Well Name: REGAL LAGER 31-19 FEDERAL COM	Well Location: T21S / R32E / SEC 31 / SESW / 32.4283053 / -103.7145063	County or Parish/State: LEA / NM
Well Number: 21H	Type of Well: OIL WELL	Allottee or Tribe Name:
Lease Number: NMNM109757	Unit or CA Name:	Unit or CA Number:
US Well Number: 3002554423	Operator: OXY USA INCORPORATED

Type of Submission: Notice of Intent

Type of Action: APD Change

OXY USA Inc., respectfully requests to amend the subject AAPD to revise the BHL, HSU, TVD and Drill Plan.

C-102 Submit Electronically Via OCD Permitting	State of New Mexico Energy, Minerals, & Natural Resources Department OIL CONSERVATION DIVISION	Revised July 9, 2024 PAGE 1 OF 2
		Submittal Type: ☐ Initial Submittal ☒ Amended Report ☐ As Drilled

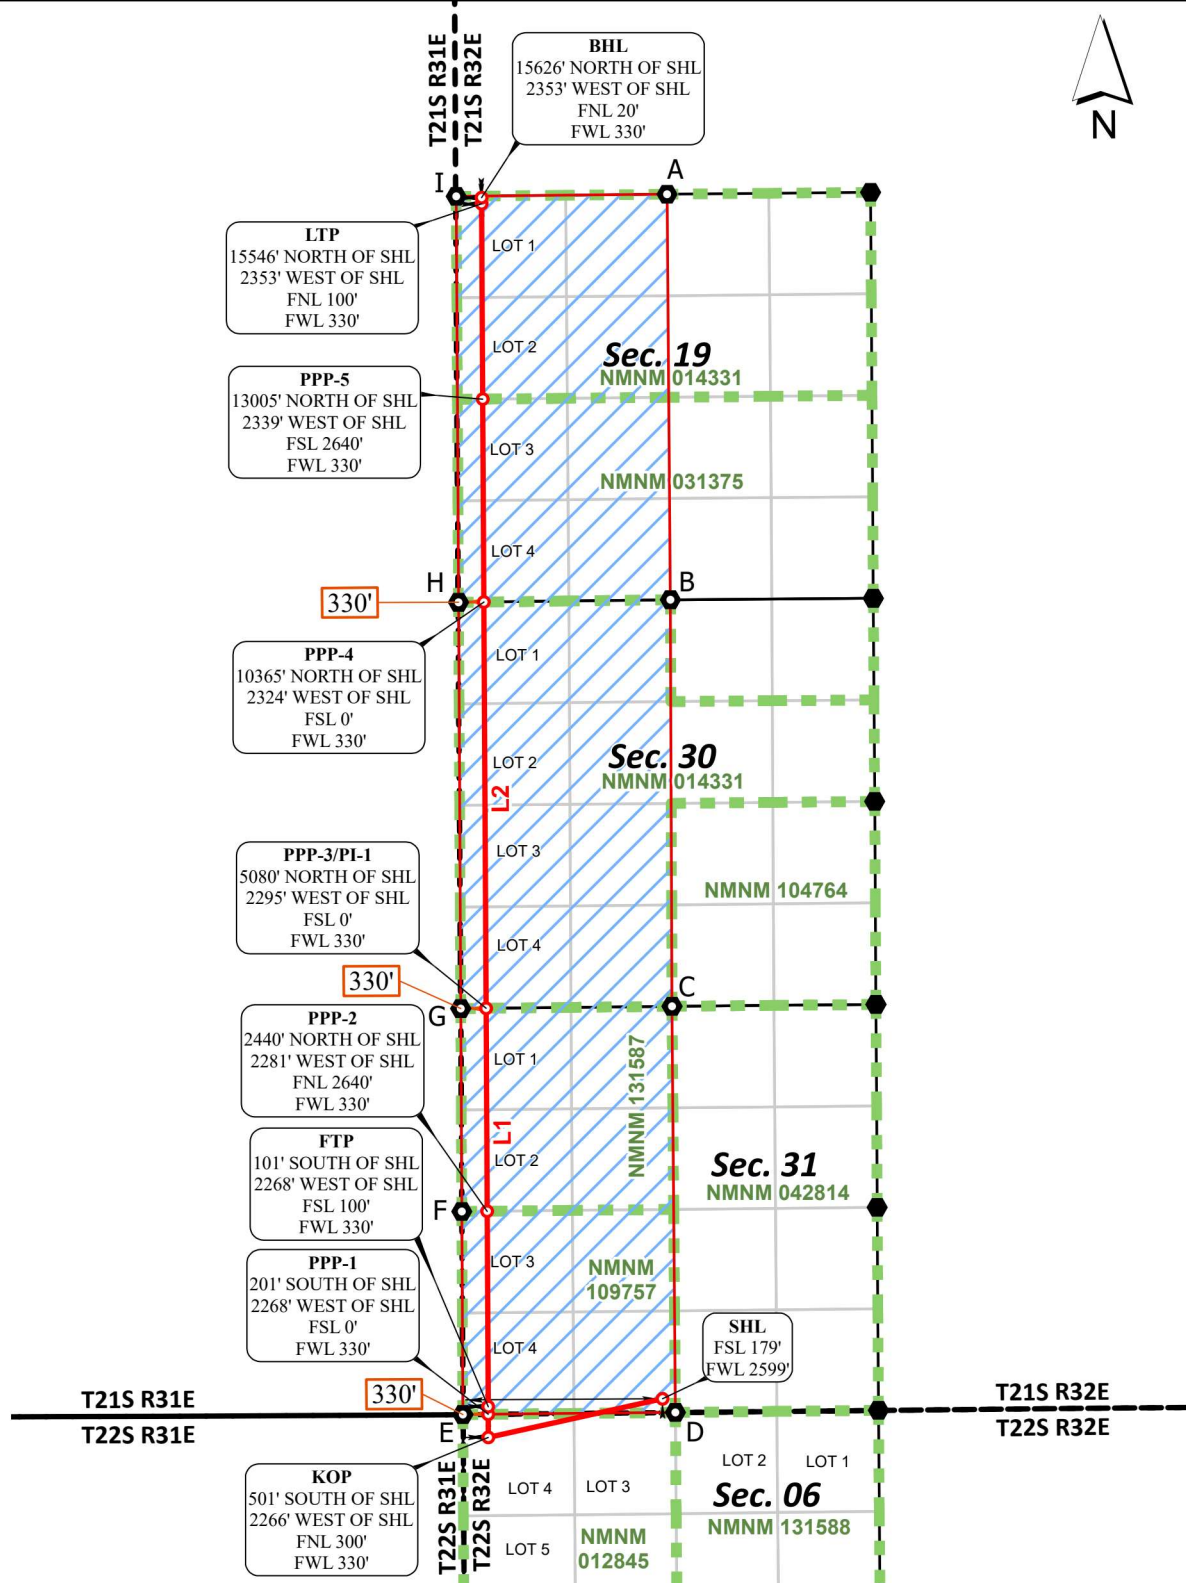
Old BHL: 20' FNL 530' FWL
New BHL: 20' FNL 330' FWL

Old HSU: 522.32 acres
New HSU: 1002.32 acres

Old TVD: 10296'
New TVD: 10897'
